To: T10 Technical Committee
From: Rob Elliott, HP (elliott@hp.com)
Date: 27 June 2006
Subject: 06-263r3 SAS-2 Spread-spectrum clocking

Figure 32 — Transmit data path in a SAS phy

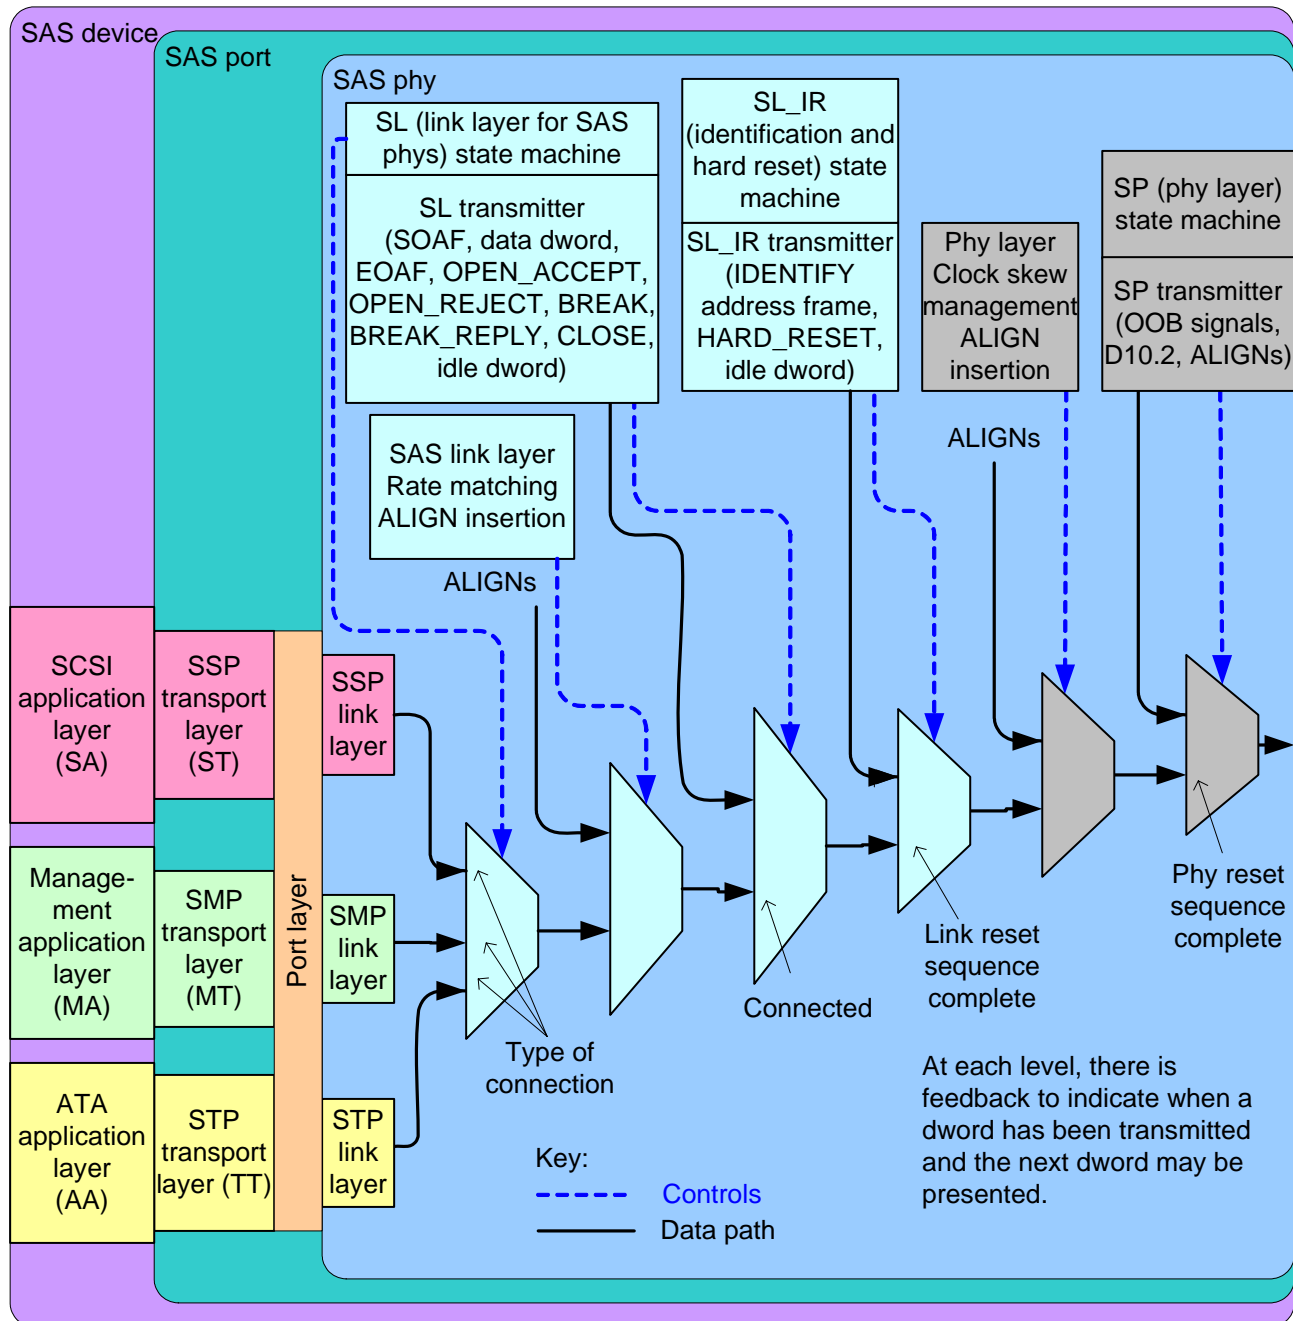
Editor's Note 2: In figure 32, change "Clock skew management" to "Clock frequency difference tolerance" (or whatever term matches section 7.3). Note that 05-381(Multiplexing) also makes changes to this figure.

Figure 33 — STP link, port, STP transport, and ATA application layer state machines

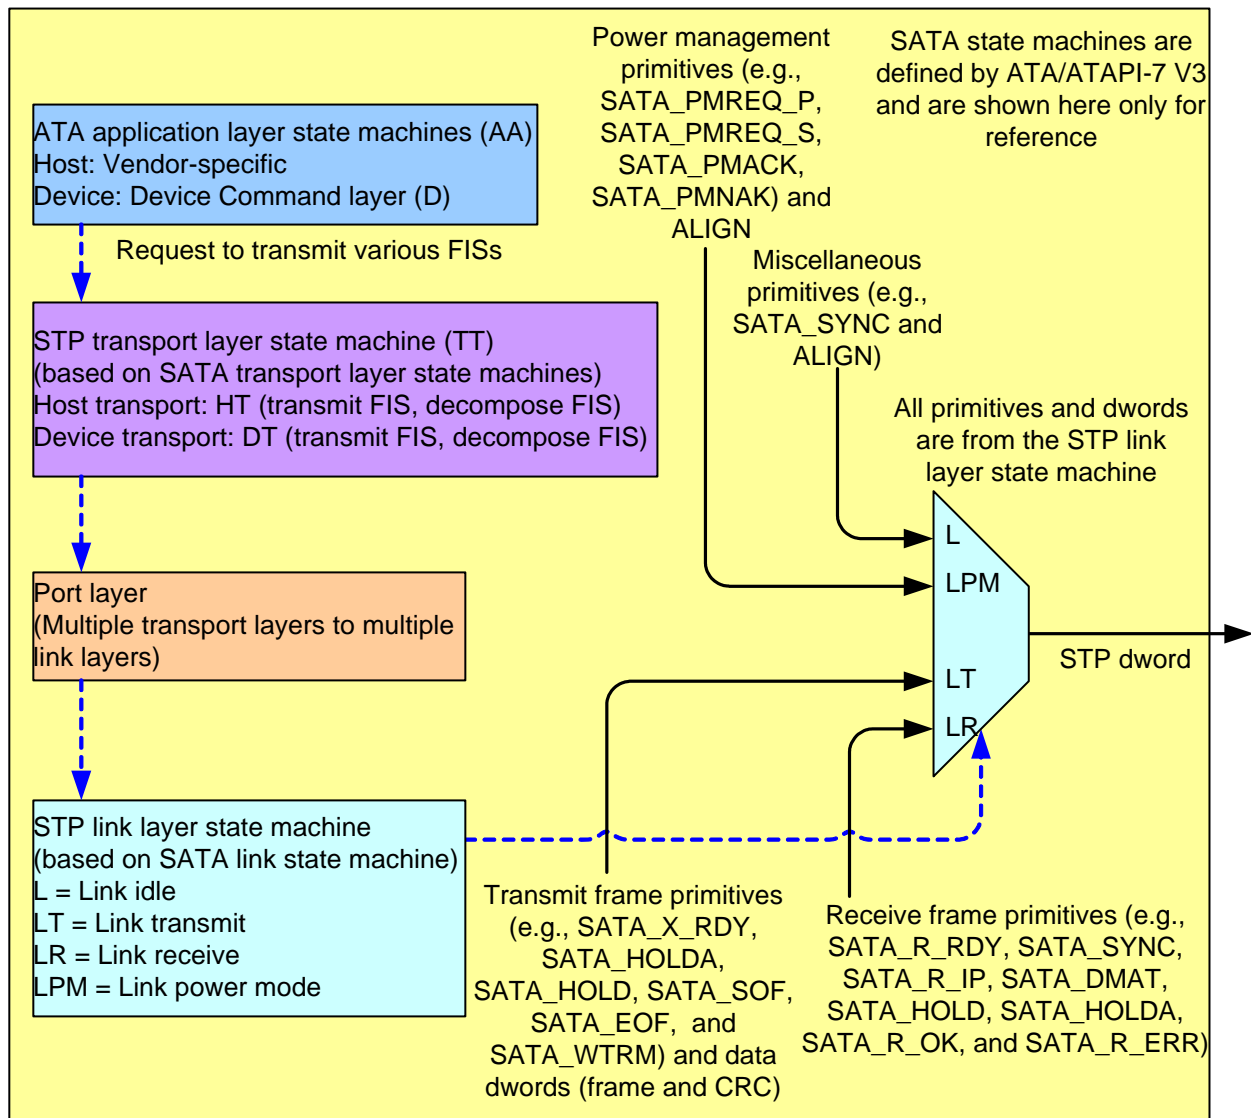
Editor's Note 3: Figure 33 should have included STP initiator phy throttling ALIGN insertion. If the fixed 1/64 ratio for all types of connections is used instead per this proposal, that is no longer a special case.

Figure 36 — Transmit data path and state machines in an expander phy

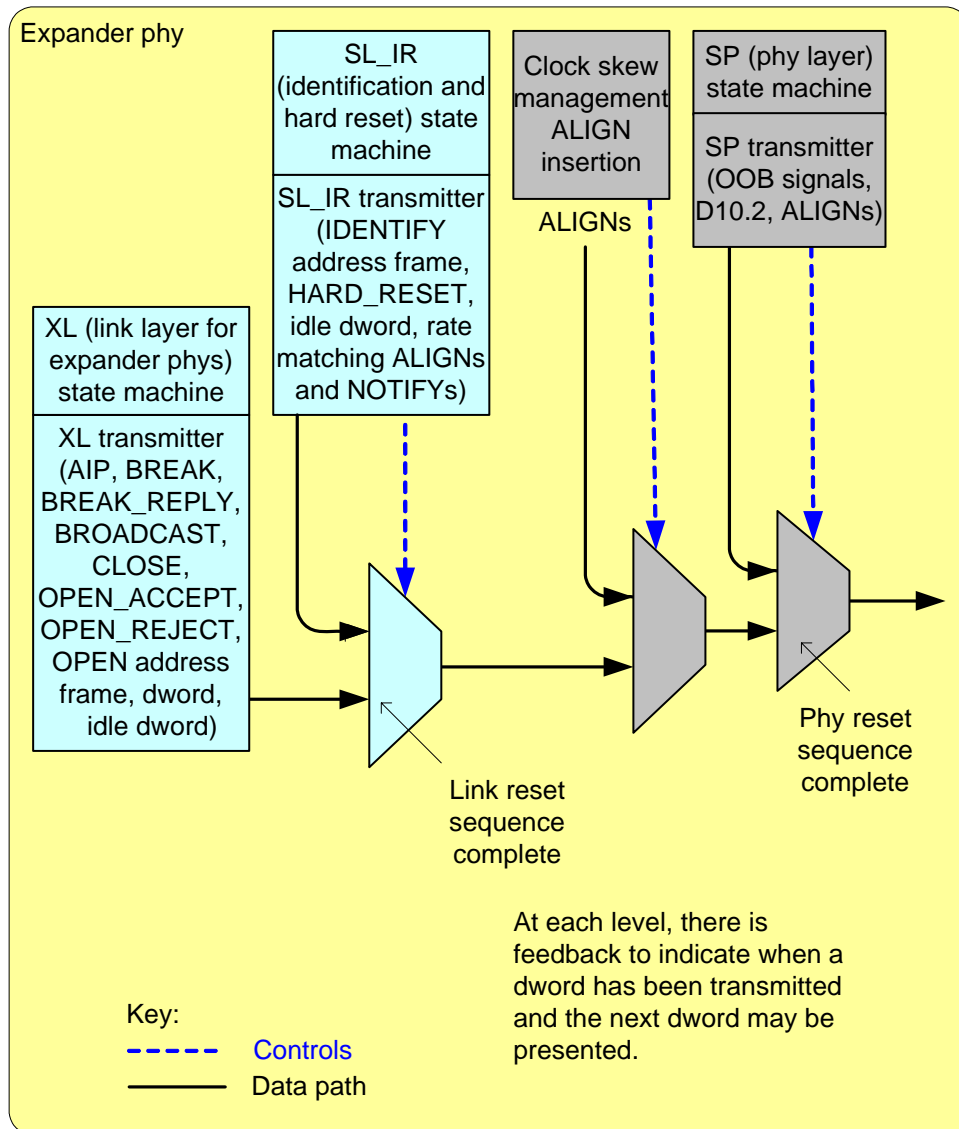
Editor's Note 4: In figure 36, change "Clock skew management" to "Clock frequency difference tolerance" (or whatever term matches section 7.3). Note that 05-381(Multiplexing) also makes changes to this figure.
